McCULLOCH CORPORATION
SERVICE BULLETIN

1531

MODEL: MAC 10-10

SUBJECT: BAR BOLT INSTALLATION

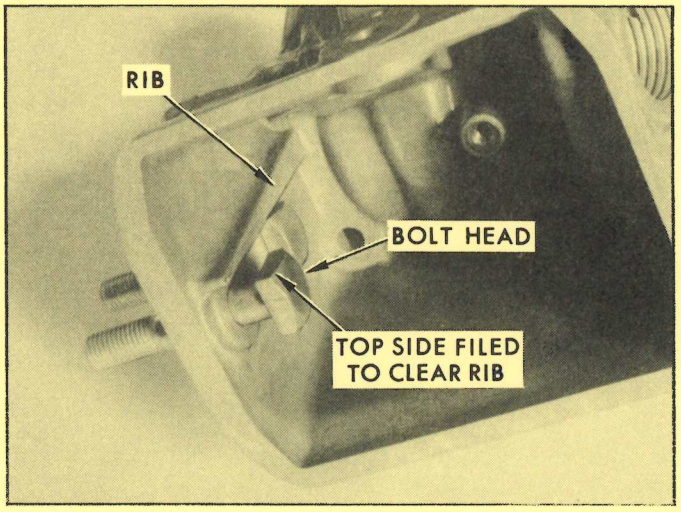
Some crankcases on MAC 10-10 saws within the serial number range of 11-26801 to 11-33800, may have slightly modified bar mounting bolts (P/N 62065) installed on the saw. One side of the bolt head may have been filed to avoid interference by the rib section on the inside of the oiler tank, when the bolt was installed. See illustration below:

Note should be made of this possible condition so that if it becomes necessary to replace one or both bar bolts with filing evident, the replacement must also be filed. Inspection of the old bolt will tell if filing is necessary on the replacement, in which case, about 1/32 inch should be the maximum required.
